## To replace Epia ML Motherboard with VB7009

## To replace Epia M830 Motherboard with VB7009

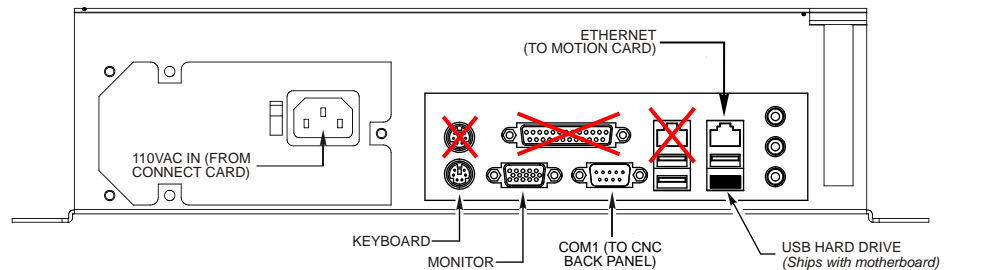
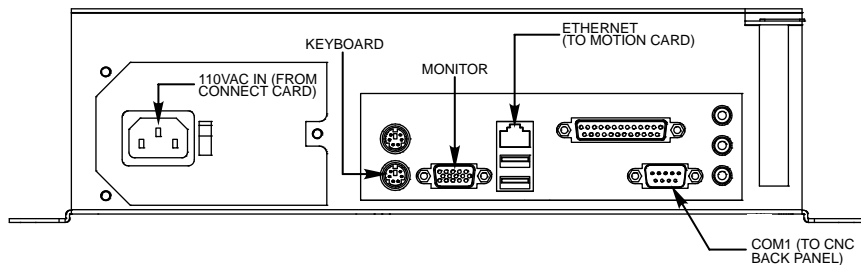
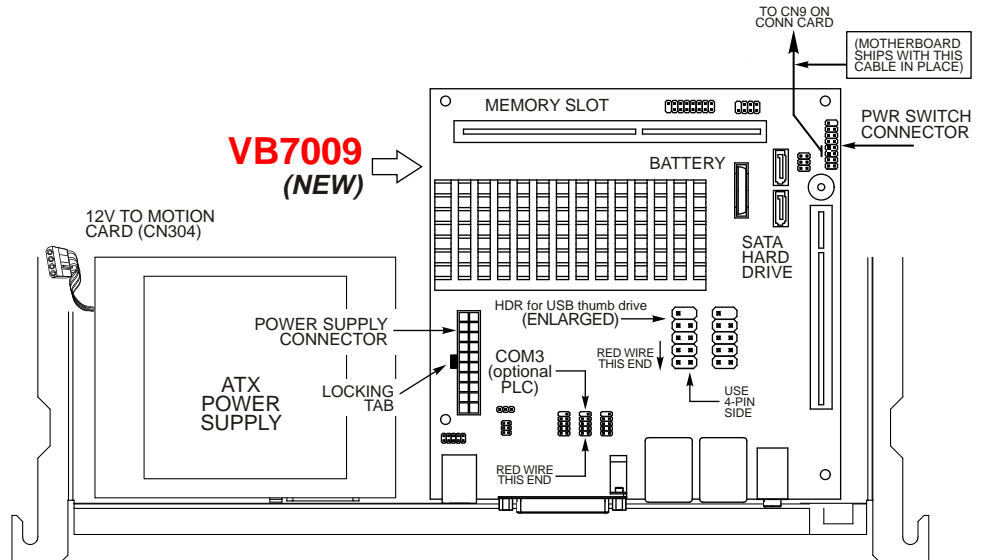
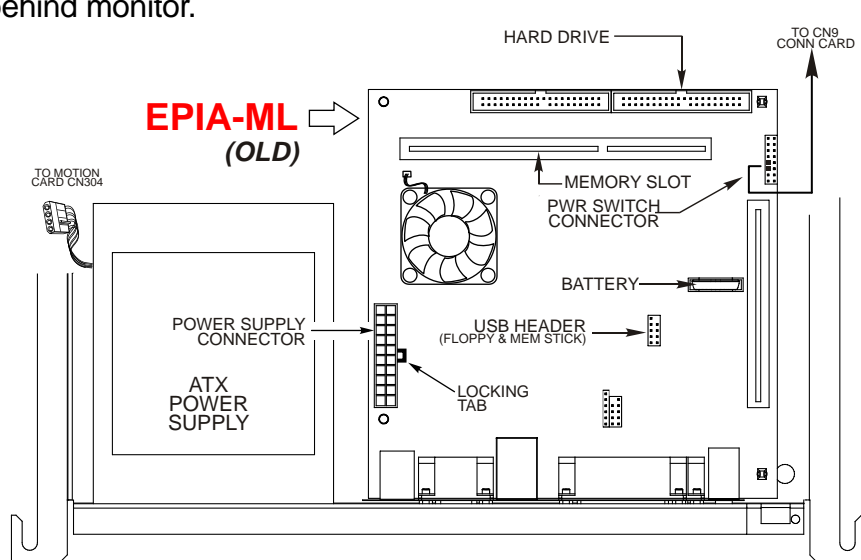
**HARD DRIVE:** The IDE hard drive ports have been replaced with SATA, so your existing hard drive will not work. *The VB motherboard ships with a USB hard drive pre-installed, configured for your system.*

**POWER CONNECTOR:** Note that the locking tab is reversed on VB.

**COM2:** If you have ribbon cable at COM2 (PLC) on Epia ML, you will need 2.5mm -2mm adapter. Install cable at COM3 on VB7009, red stripe toward front. Route this cable to the RS422 converter module behind monitor.

**USB HEADER:** If you wish to continue using floppy for backup, you must release the floppy disk while CNC boots up, then push it in to backup your program files. Probably better to use USB for backup.

**PWR SWITCH CONNECTOR:** Motherboard is shipped with cable connected to this header. These connections are unchanged from ML to VB, so you may wish to remove the cable at the header and use your existing cable. Otherwise, route this cable to the RS422 converter module behind monitor and connect to CN9 on connect card and discard your original cable.

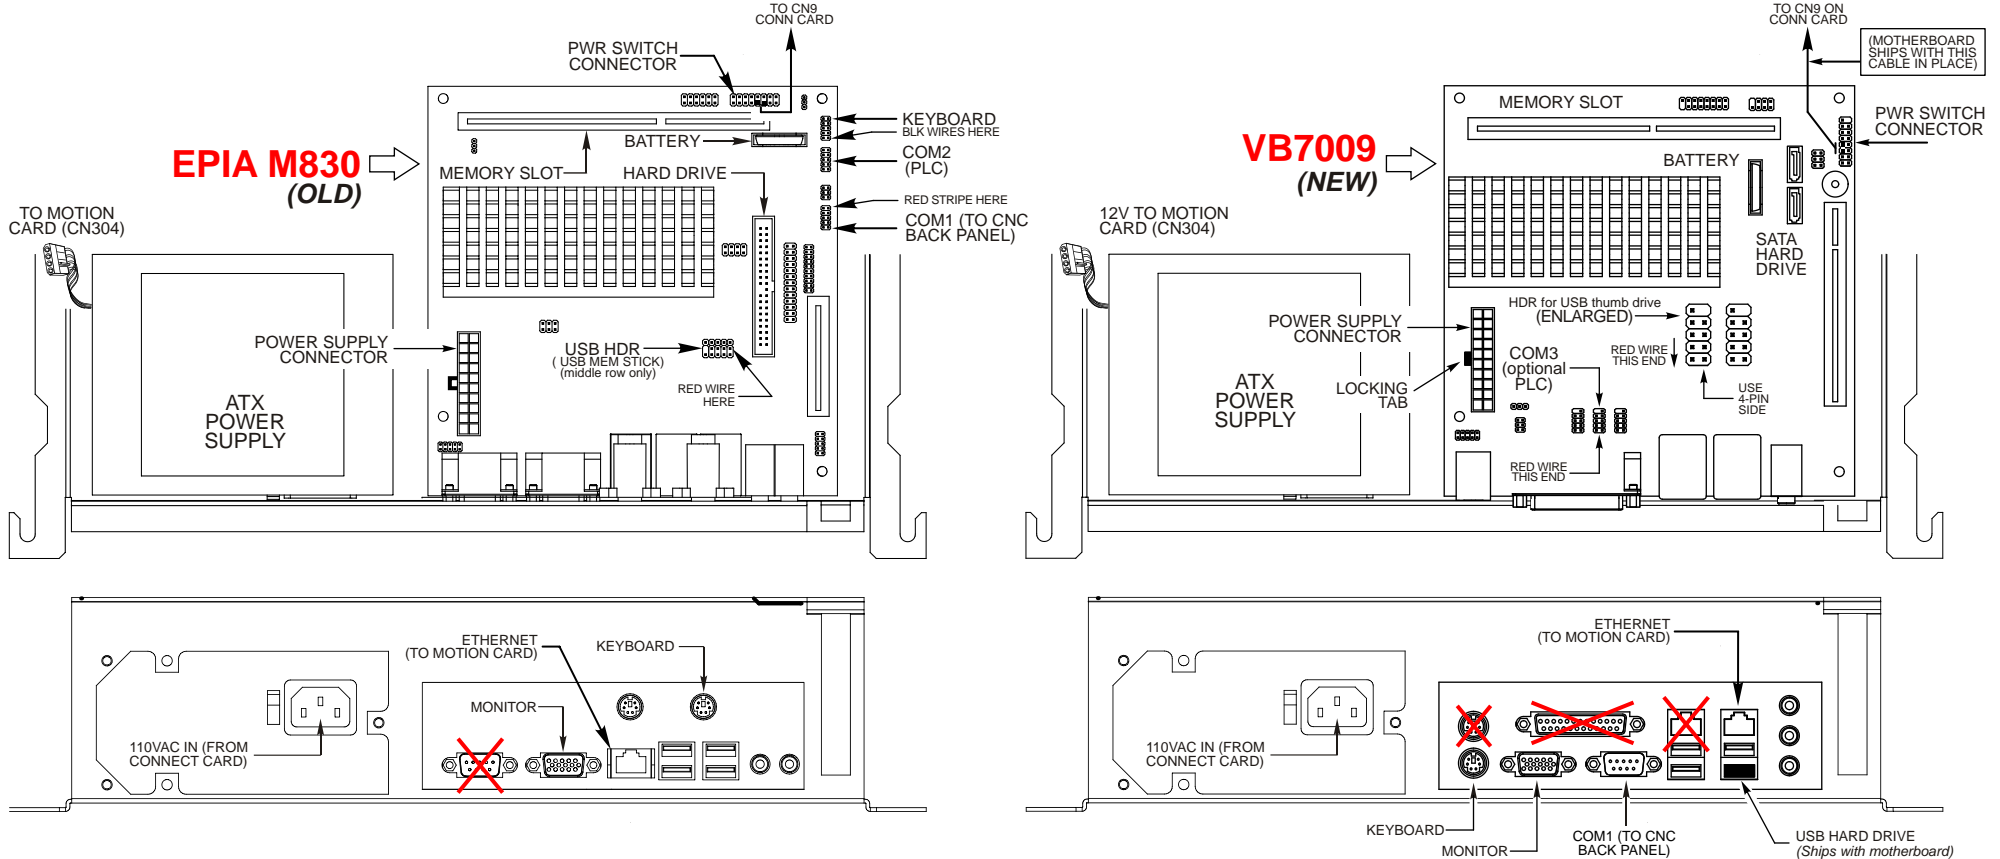
**HARD DRIVE:** The IDE hard drive ports have been replaced with SATA, so your existing hard drive will not work. **The VB mother board ships with a USB hard drive pre-installed, configured for your system.**

**PWR SWITCH:** Moved from back to right side. Motherboard is shipped with cable connected to this header. These connections are unchanged from M830 to VB, so you may wish to remove the cable

at the header and use your existing cable. Otherwise, route this cable to CN9 on connect card and discard your original cable.

**COM1:** The 10-pin ribbon-cable from header on mother board must be replaced with cable provided. Connect 9-pin female to COM1 connector on computer panel; route 9-pin male to CNC rear panel.

**COM2:** If you have ribbon cable at COM2 (PLC) on Epia M830, move that cable, including adapter, to COM3 on VB7009. Red stripe goes toward front.
